RESPONSE TO REQUEST FOR ADDITIONAL INFORMATION

US-APWR Design Certification

RAI NO.: NO. 1040-7139 REVISION 3
SRP SECTION: 03.08.01 – Concrete Containment
APPLICATION SECTION: 3.8.1
DATE OF RAI ISSUE: 07/01/2013

QUESTION NO. 03.08.01-21:

Figure 1 Section View and Stresses

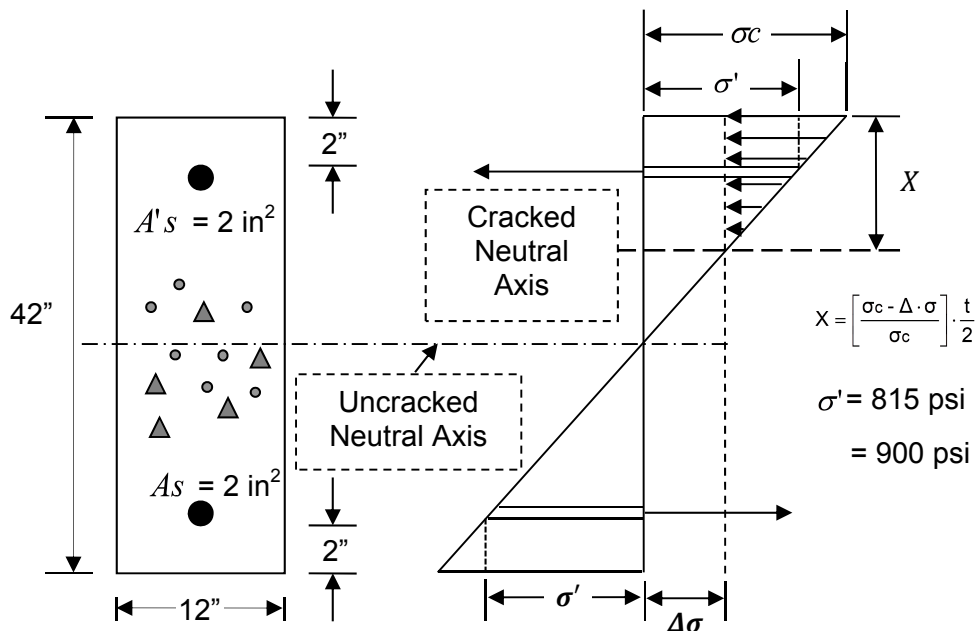
The applicant is requested to describe (1) the result of the evaluation on the PCCV due to the liner plate spike load, (2) how the concrete cracking was considered in the evaluation, and (3) the changes of the PCCV design as a result of the liner plate spike load.

The following example is provided to show how concrete cracking in the PCCV cylindrical section is considered. The stress across a concrete section is calculated as an un-cracked section initially and then the stress due to concrete cracking is calculated to adjust the concrete section given the effects of the cracked concrete behavior.

The example presented herein is an example of a PCCV concrete section when subjected to a thermal gradient with reinforcement provided on both faces and concrete cracking is considered. PCCV concrete section evaluation due to liner plate spike load uses the same approach.

$$\sigma = \frac{1}{2} aEc\Delta T = 900 \text{ psi}$$

$$\Delta\sigma = 511.9 \text{ psi, use } \Delta\sigma = 512 \text{ psi}$$

$$X = \left(\frac{\sigma - \Delta\sigma}{\sigma} \right) \frac{t}{2} = \left(\frac{388}{900} \right) 21 = 9.05 \text{ in}$$
